DRAWING AMENDMENTS

Device and Method for Protecting a Motor

Vehicle Against Theft

Attorney Docket.: 071308.0549

FIG 1

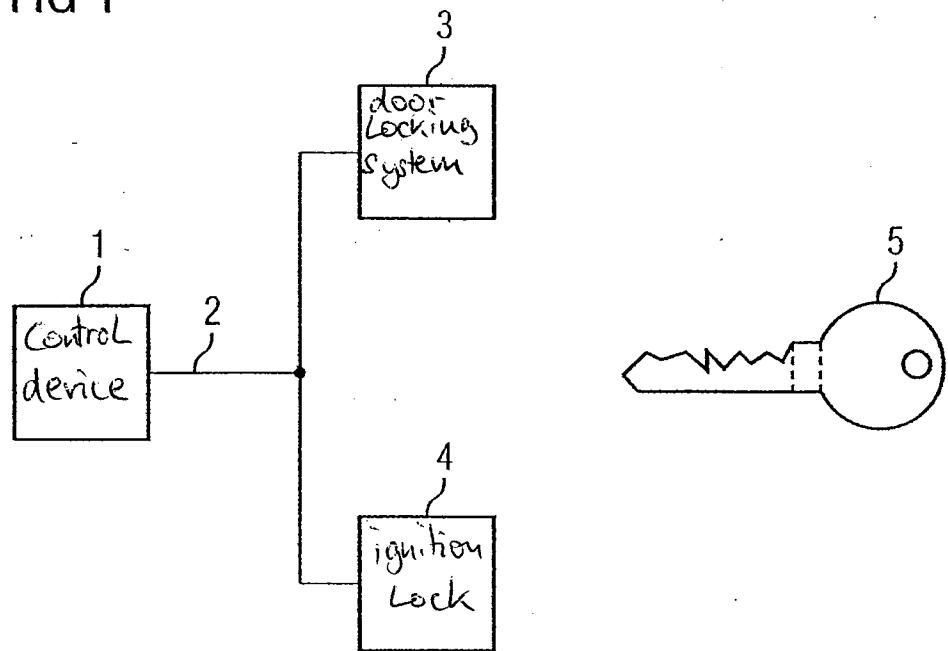
The drawings were objected to for failing to show every feature of the invention as specified in the claims. Please replace Drawing Sheet(s) 1-3, Figure(s) 1-3 with replacement Drawing Sheet(s) 1-3. Applicants also submit annotated red-lined drawing pages reflecting the changes. Applicants provide formal corrected drawings to be entered if the proposed changes are accepted by the Examiner.

Annotated Sheet 2/3

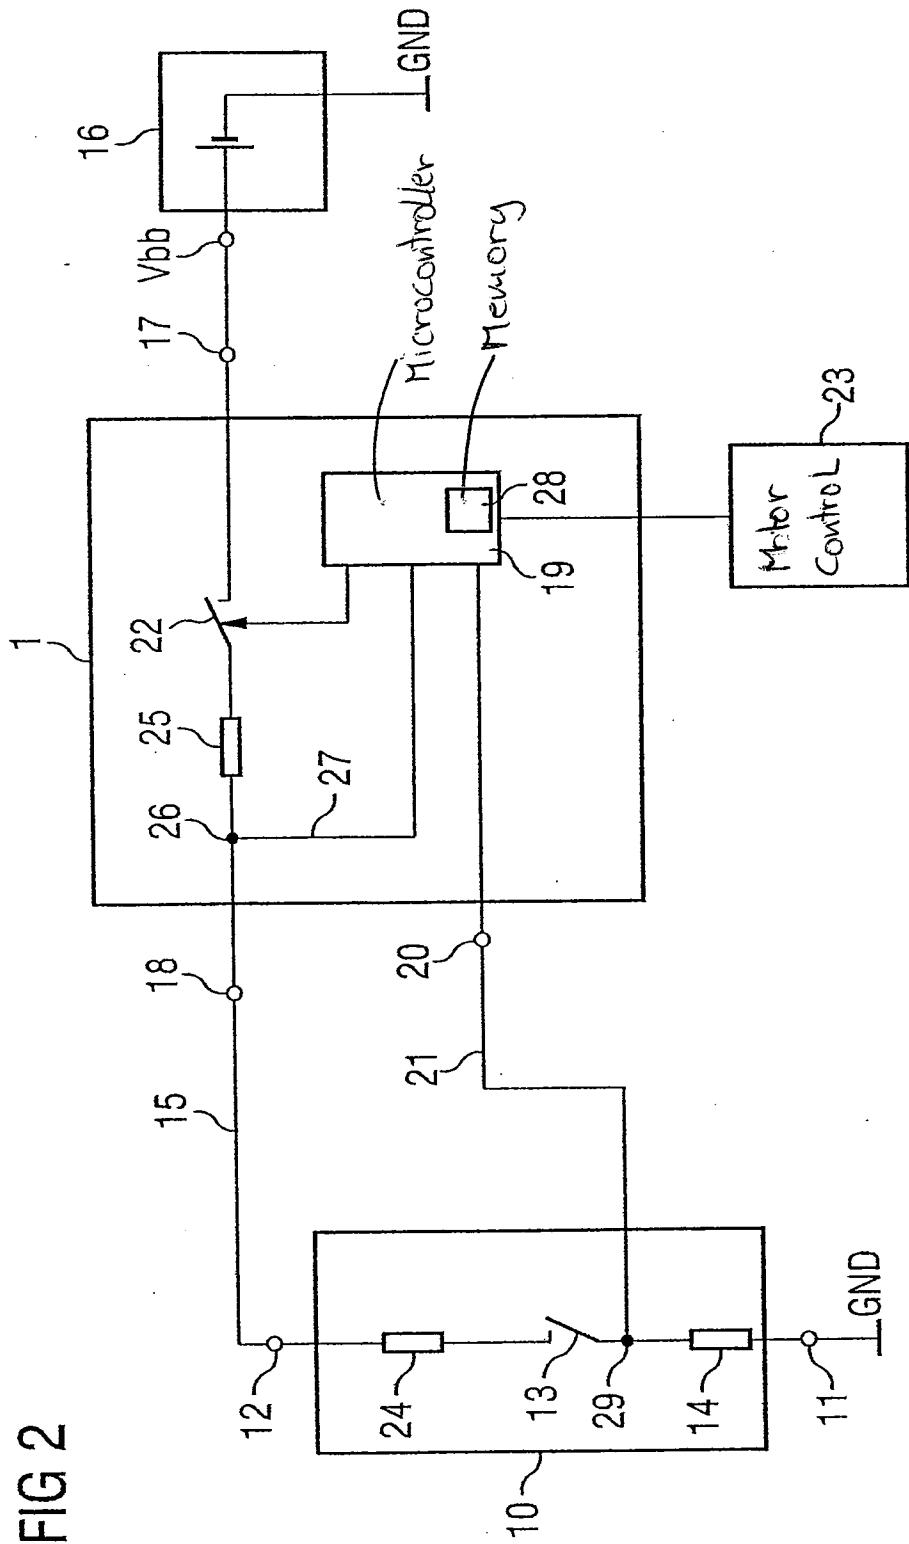
Examiner has objected to the drawings for not showing every feature of the invention specified in the Claims under 37 CFR 1.83(a). Applicants submit that the diagnosis and evaluation unit is shown in Fig. 2 with element 19. Element 19 can for example be a microcontroller which performs the functions of the diagnosis and evaluation unit as described in the specification of the present application. therefore, all claimed limitations are shown in Fig. 2.
